Access Compliance Report Public Rights-of-Way (Curb Ramps)

Main Street: SHAKESPEARE_DR		Cross Street: KENSINGTON_RD		Location:	SW
ADA ID: RPAT211201103303	Ramp Type:Type 1 - Perpendicular Diagonal Initial Pass/Fail: Fail		Overall Compliance: No	Severity Score:	16
Codes/Mitigation Info/Possible Solution			Field Measurements/Component Compliance

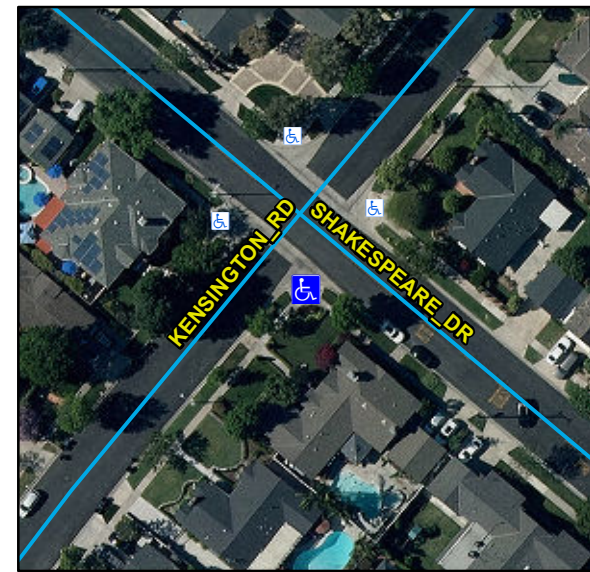
Remove & Replace Curb Ramp With Two New Directional Ramps or Equivalent.

R304.2.2, R204.3, STD 1115
